**CONTINENTAL MOTORS® AIRCRAFT ENGINE  
CRITICAL SERVICE BULLETIN**

**CATEGORY 2  
CSB15-7B**

**SUBJECT:** TSIO550-K Oil Cooler Cross Fitting Replacement

**PURPOSE:** To replace oil cooler cross fitting (P/N AN918-1J) with a new enhanced cross fitting (P/N 658607).

Figure 3. Cross Fitting, Comparison

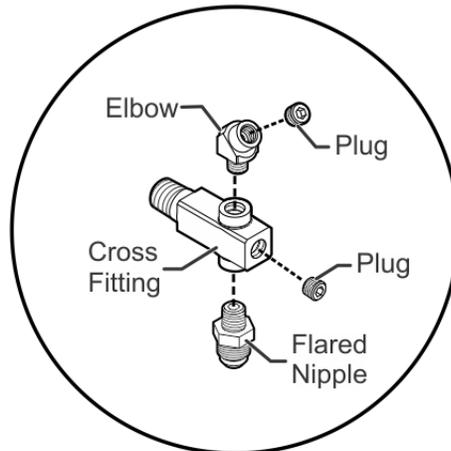
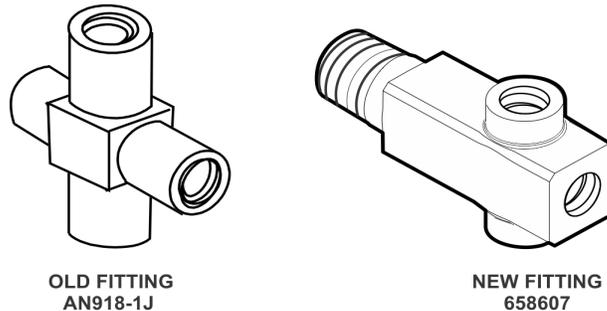
Continental Motors (CM) published CSB15-2 upon discovering isolated occurrences in which there was a loss of engine oil due to a fractured nipple fitting between the cross fitting (P/N AN918-1J) and the pipe bushing at the oil cooler. Design improvements consolidate the oil cooler cross fitting stack-up into a single part, significantly increasing the strength and providing a simplified procedure for installing the oil cooler cross fitting found on specified TSIO550 engines. *If compliance was previously achieved through CSB15-2 on the TSIO550-K engine, no further action is required. Modifications described herein on engine serial numbers 1012296 and higher were accomplished at the factory.*

- Eliminate the pipe bushing and nipple fitting stack-up (see Figure 1) typically found between the cross fitting and the oil cooler and replaces them with a single cross fitting (P/N 658607).
- Provide a larger tool surface area on the cross fitting for support wrenches during subsequent fitting and B-nut installation.

REMOVE AND REPLACE the superseded parts with new cross fitting (P/N 658607) using the same procedures located in your M-18 Maintenance and Overhaul Manual. Reference the latest revision of the CM Illustrated Parts Catalog (IPC) to determine applicable additional connectors, elbows, or plug part numbers and adjust the instructions accordingly.

**Figure 4. Hose and Tube Installation Support**

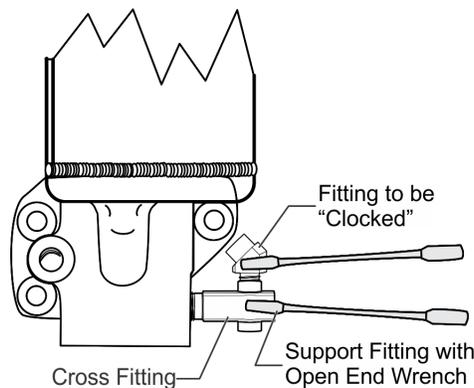
- b. Support the last fitting in the assembly on components that contain multiple fittings coupled in one location (see Figure 4). DO NOT over-torque fittings.

- a. Use a wrench on both mating connections to avoid applying excessive torque to the fittings. Securely tighten fittings and torque to the specified value in Appendix B. Torque the hose or tubing end fitting while maintaining sufficient force on adjacent fittings to prevent twisting and shear loads.
